Product Change Notice

JENSEN[®] JE2412LED

The JENSEN[®] JE2412LED will be changing to a different IO configuration. The new Rev Level is denoted by the LH design changing from the previous design of Rev Level KH. This change will be effective immediately.

New LH Revision IO Configuration:

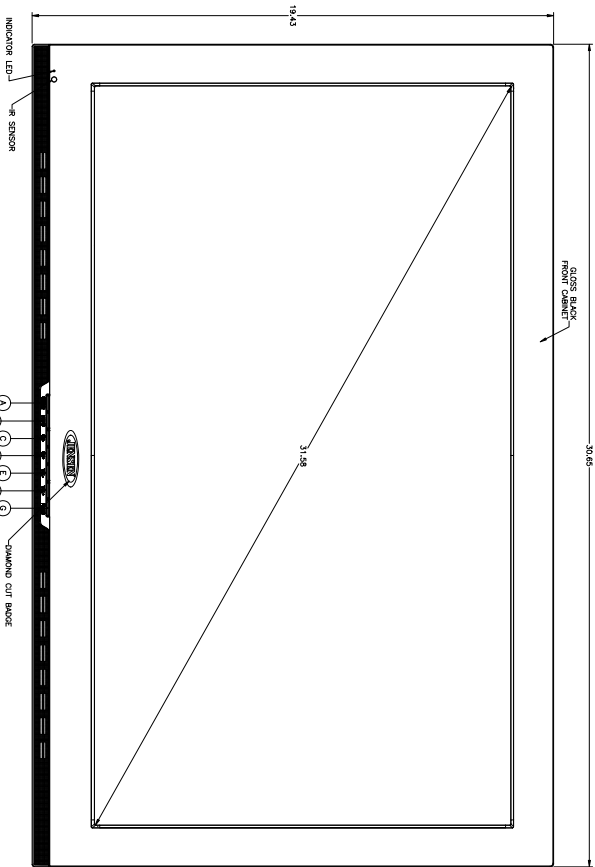
Former KH Revision IO Configuration:

- Composite video input x 2 (NTSC/PAL)
- Stereo audio input x 2
- VGA with 3.5mm audio input
- RF x 1
- USB
- HDMI input x 2
- Selectable (variable/fix) line level audio output (RCA)
- Digital SPDIF audio output (RCA)
- IR repeater (JENSEN DVD control)

- Composite video input x 1 (NTSC/PAL)
- Component video input x 1
- VGA with 3.5mm audio input
- RF x 1
- USB
- HDMI input x 2
- Selectable (variable/fix) line level audio output (RCA)
- Digital SPDIF audio output (RCA) x 1
- PC audio input

- Please note there are no changes to the cabinet or mounting pattern.
